ADDRESS: 8002 KERCHEVAL

APPLICATION NO: HDC2025-00640

HISTORIC DISTRICT: WEST VILLAGE

SCOPE: REPLACE SIDING WITH FIBER CEMENT SIDING

8002 Kercheval, west/side elevation. Current condition. Photo by applicant, notes added by staff.

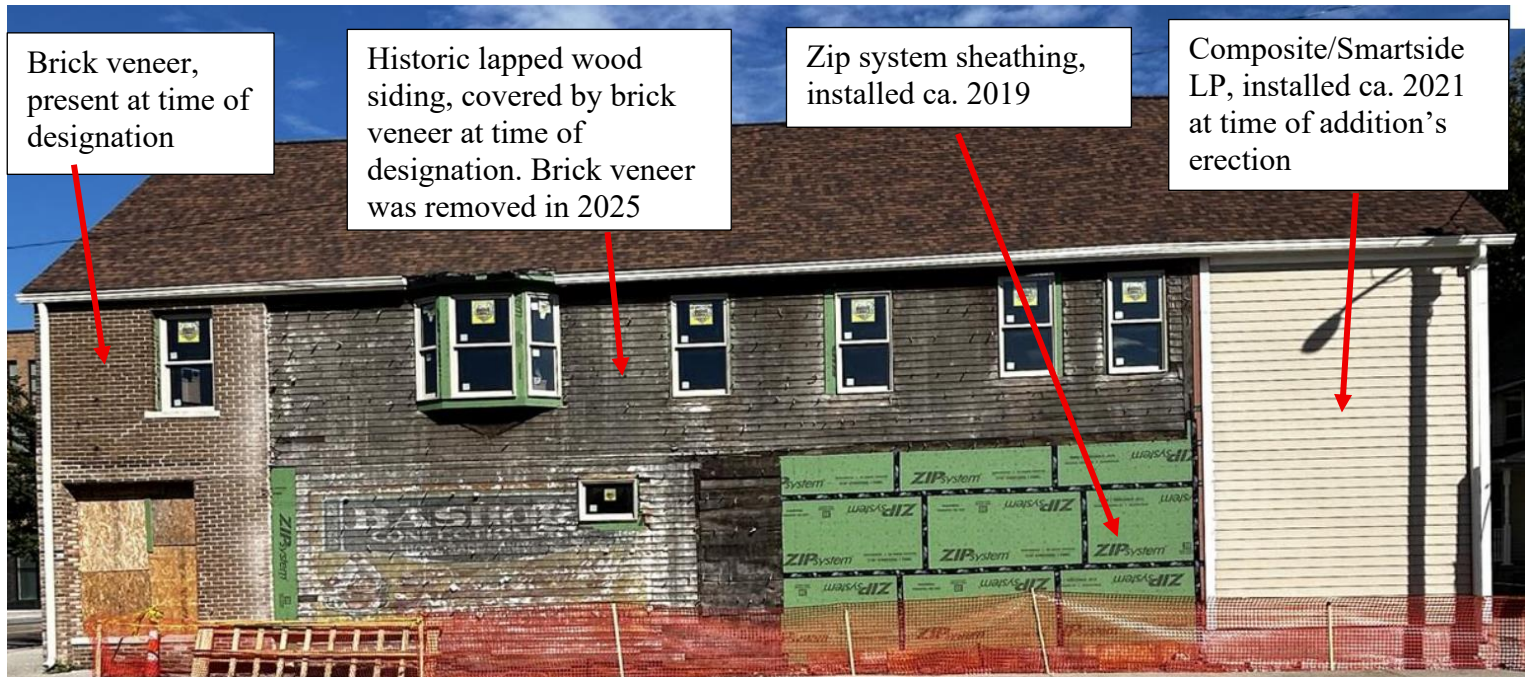
- The historic wood siding at the side elevations has only recently been revealed after the removal of the brick veneer and asphalt/Insulbrick siding. Staff was able to view the condition of the siding from the public right-of-way and did not find that it was deteriorated to an extent that merits its wholesale removal as proposed. Also, the application does not provide documentation that the historic wood siding is deteriorated beyond repair.

- Staff notes that the presence of an historic sign for "Bashor Confectioner Homemade Candy" at the first story of the newly revealed wood siding at the building's west façade (see above photos). Historic District Commission's "Signs and Awning" guidelines [Microsoft Word - Signs & Awning Guidelines FINAL](#) recommend that property owners "preserve historic signage when possible." Similarly, the National Park Service recommends that historic signs be retained whenever possible, particularly when they are "significant as reflecting the history of the building..." [Preservation Brief 25: The Preservation of Historic Signs](#). Research of historic newspapers (see below) revealed that the building housed businesses related to confectionary/candy making as early as 1927 through the 1960s.

8002 Kercheval, front facade. Showing brick veneer at first and second stories. Asphalt/Insulbrick siding is present at the third-story gable end. Current condition. Photo by HDC staff, 10/27/2025.

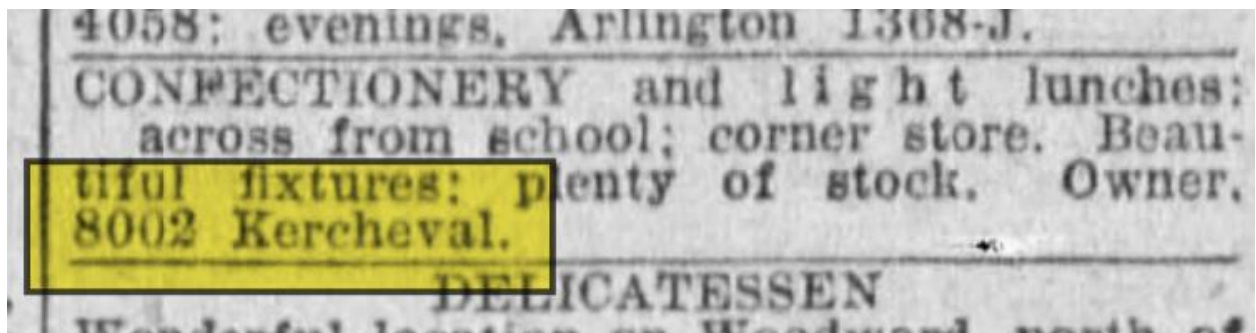
- The application has not demonstrated that historic wood siding does not remain beneath the asphalt/Insulbrick at siding at the front façade's third-story gable end.
